MFN 06-204

Subject: **Response to Portion of NRC Request for Additional Information
Letter No. 6 Related to ESBWR Design Certification Application –
Tier 1 – RAI Numbers 14.3-1 and 14.3-4**

Tier 1 – RAI Numbers 14.3-1 and 14.3-4

Figure 14.3-1-1 Tier 1 Design Description and ITAAC Update Process

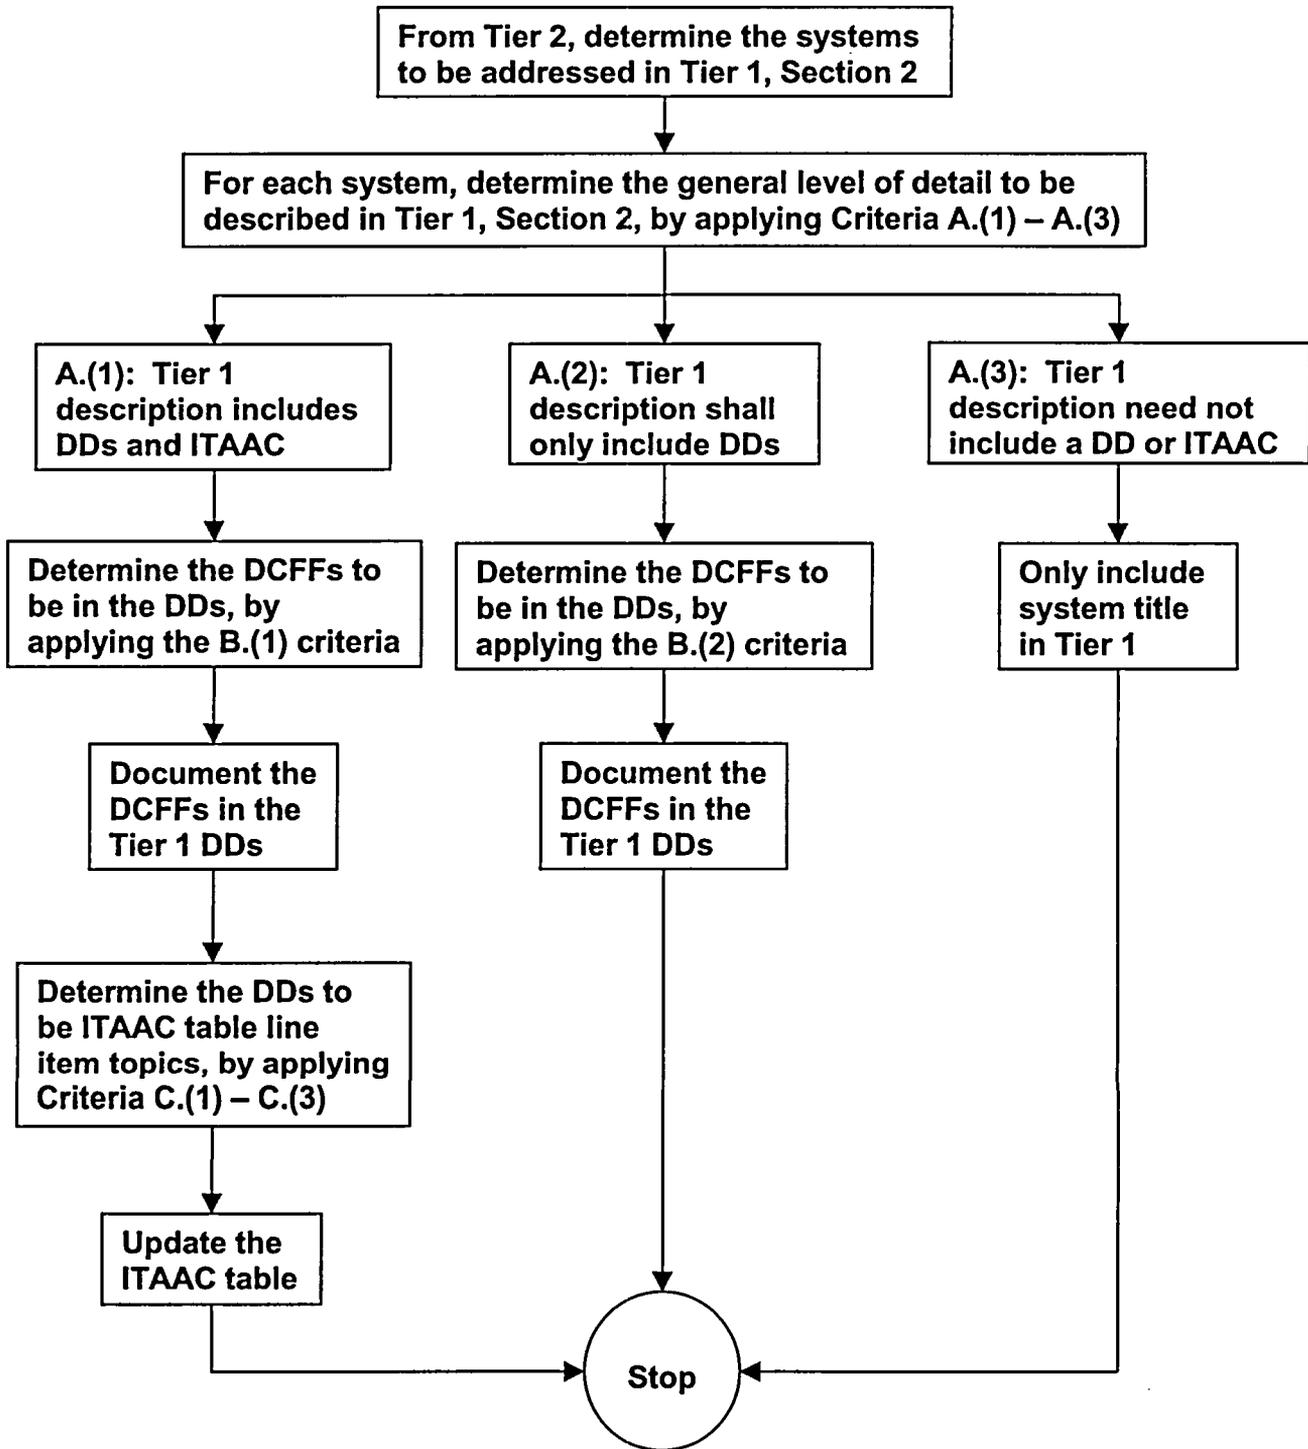
Provide DCD, Tier 1, ITAAC commitments which include the attributes of the system and its components. This would include not only operational tests, currently listed, of the systems and components but also each of these separate ITAACs and their associated design basis accident conditions:

- *Seismic capability of all Category I equipment.*
- *Surge withstand capability (SWC) of Class 1E equipment.*
- *Electromagnetic interference (EMI) capability of Class 1E equipment.*
- *Radio frequency interference (RFI) capability of Class 1E equipment.*
- *Electrostatic discharge (ESD) capability of Class 1E equipment.*
- *Environmental capability of Class 1E equipment including room ambient temperature, humidity, pressure and vibration conditions.*
- *Class 1E equipment is powered from its respective Class 1E source.*
- *Separation is provided between Class 1E divisions, between Class 1E divisions & non-Class 1E systems.*
- *The system initiates automatic initiation of ESF and/or RPS as identified when plant process signals reach identified limits.*
- *Data communication between safety and nonsafety systems do not inhibit the performance of the safety function.*

The inspections tests or analyses, for many of the qualification attributes would be confirmation that a report exists and concludes the particular function is provided.

To ensure the appropriate level of detail for Tier 1, GE proposes to (a) add sets (shown below) of Tier 1 DD and ITAAC selection criteria into Tier 2 Subsection 14.3.2, (b) add an application process into Subsection 14.3.2, (c) update the Tier 1 system DDs, (d) update the ITAAC based on the updated DDs, and (e) provide resulting changes in future revisions of Tier 2, Section 14.3 and Tier 1, Chapter 2.

To ensure compliance with 10 CFR 52 in a thorough and consistent manner, GE proposes to re-review and update, as needed, Section 14.3 and the Tier 1 system DDs and ITAAC using the process outlined below and illustrated in Figure 14.3-1-1.
